Department of Electronic and Telecommunication Engineering  
University of Moratuwa

EN2160 – Preliminary Design Report  
Morse Code Encoder Decoder

This report is submitted as partial fulfilment of the module EN2160 - Electronic Design Realization  
16 June 2023

## Schematic

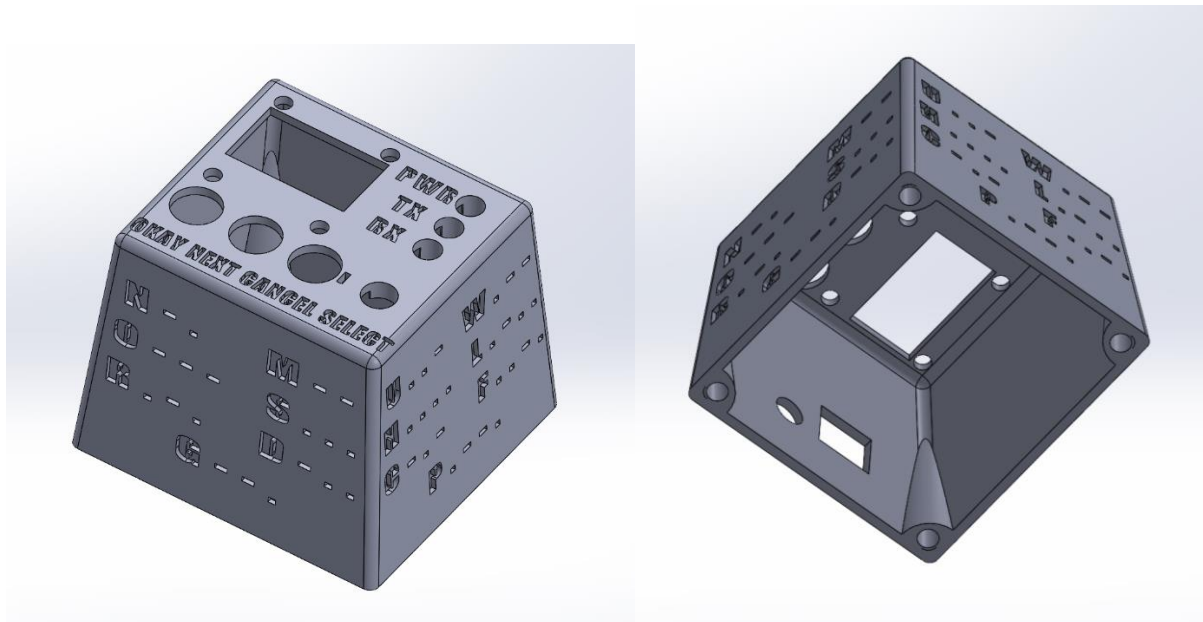
- The annotations do not adhere to the expected professional standards as mentioned by Prof. Jayasinghe. Specifically, they are not arranged in a sequential manner from left to right and top to bottom as required.
- The placement of inputs and outputs is incorrect. Prof. Jayasinghe recommended that inputs be positioned on the right side, while outputs should be positioned on the left side.
- The schematic is hard to read and comprehend. It should be simplified. The example schematic design provided by Prof. Jayasinghe is a proper reference to how a professional schematic should be.

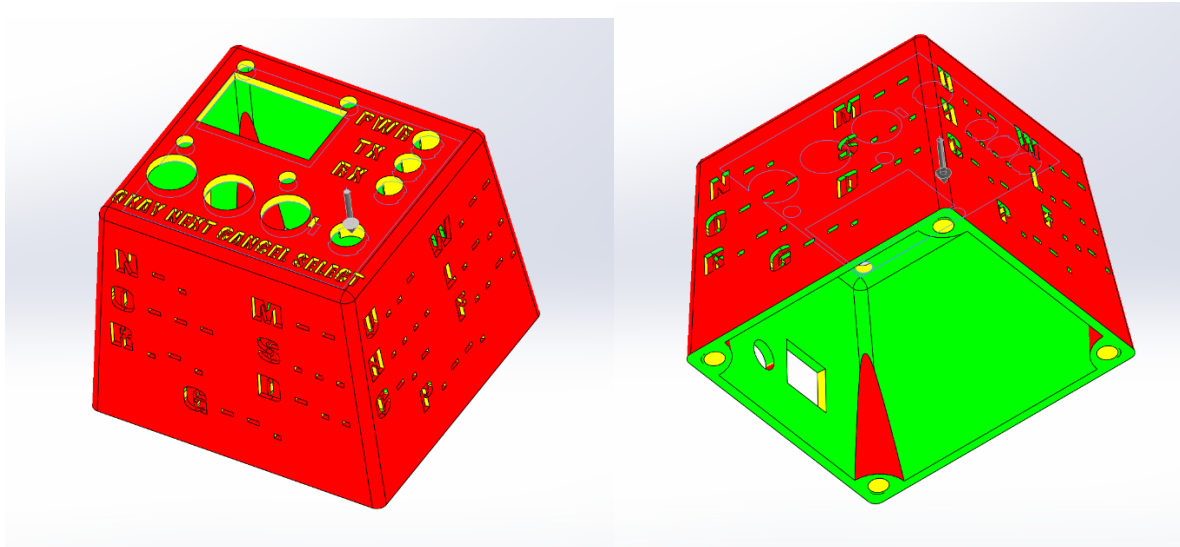
According to the draft analysis, this cannot be injection moulded.

- I was previously unaware of the intricacies involved in injection moulding and the manufacturing process of a product. However, thanks to the invaluable teachings of Prof. Jayasinghe, I have gained a newfound understanding. Upon examining the draft analysis, I have come to the realization that the enclosure of my product is unsuitable for injection moulding. Notably, the yellow-coloured areas depicted in the images present challenges as they cannot be effectively moulded, particularly the intricate lettering.

Schematic – Simplified to 2 pages. Corrected all the mistakes.

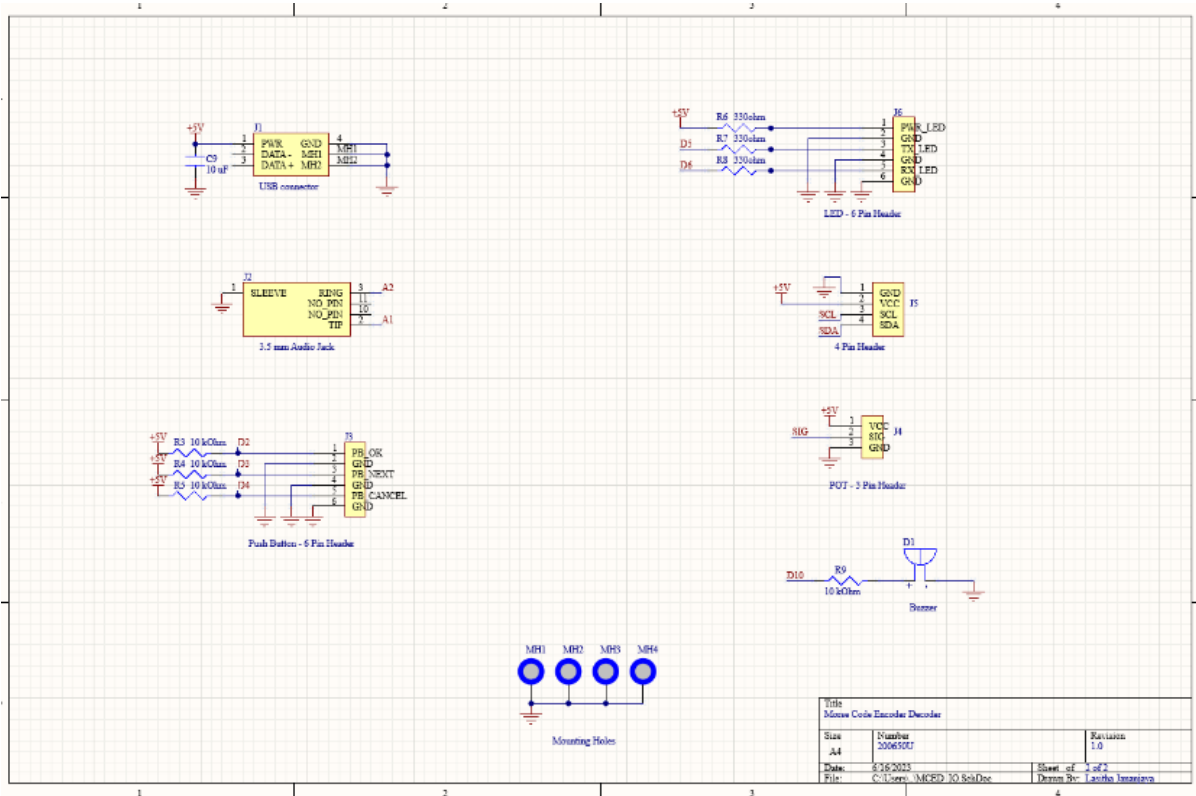
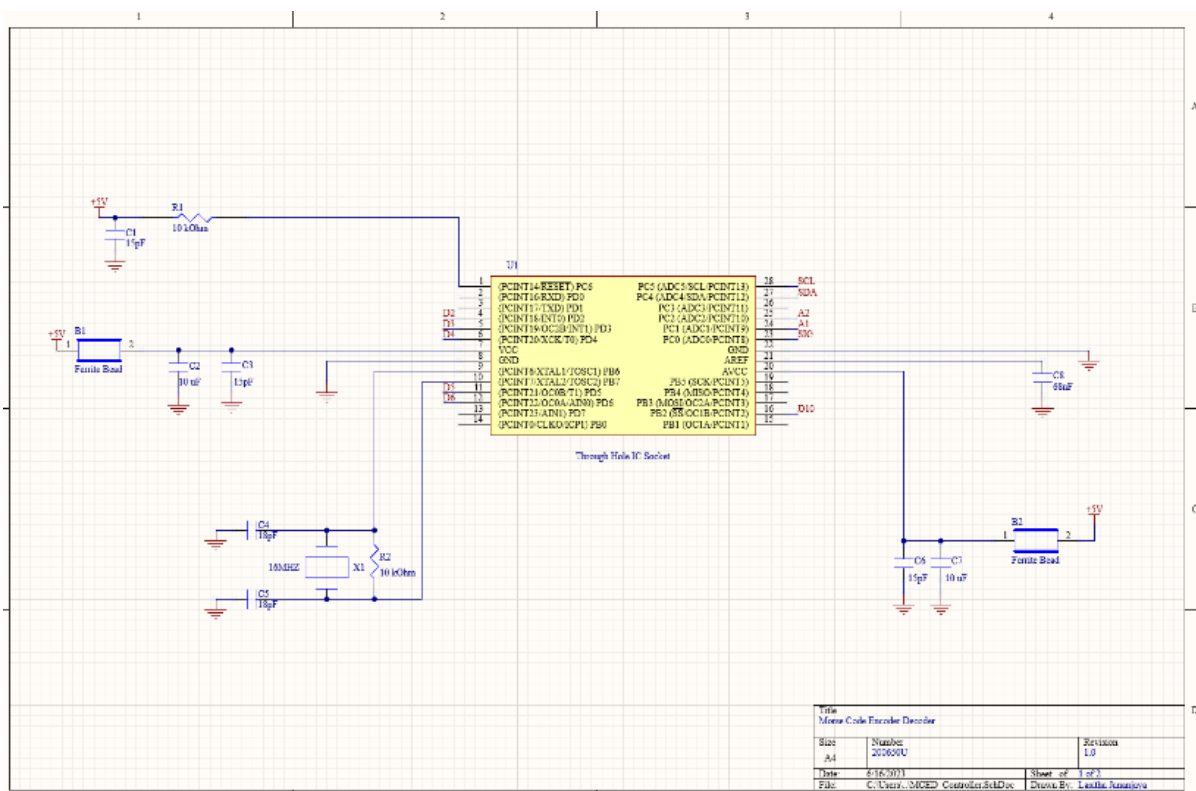
- One suggestion was made to increase the volume of the buzzer. The resistance value of the resistor which connects to the buzzer was then reduced.
- Another suggestion was made to increase the button debounce time. Since that typically causes errors. That was adjusted as required.

## Solid work design

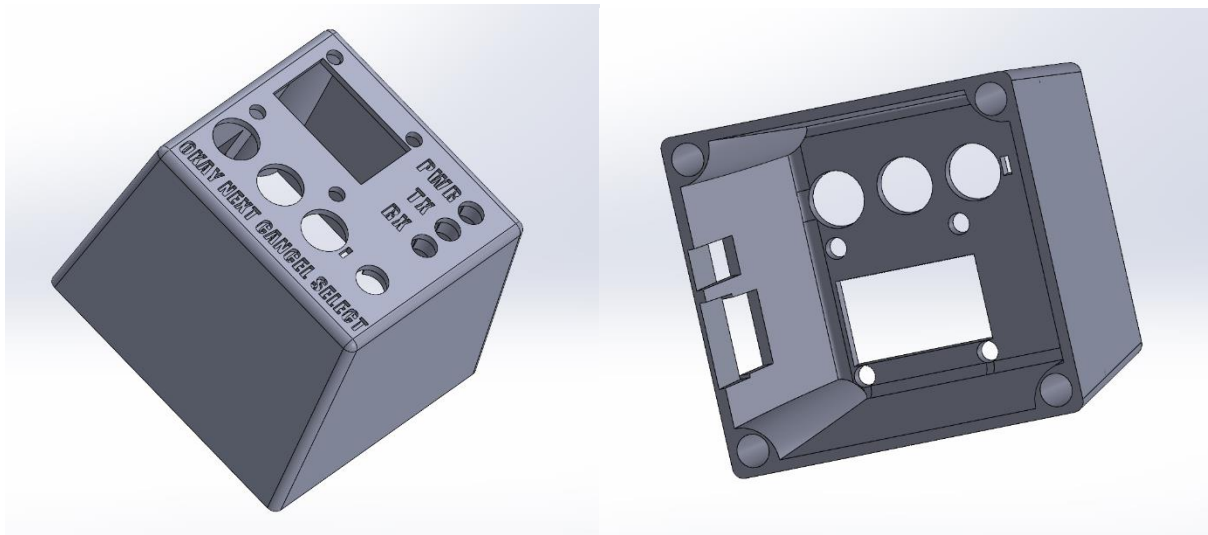
Draft analysis – There are no yellow-coloured regions now
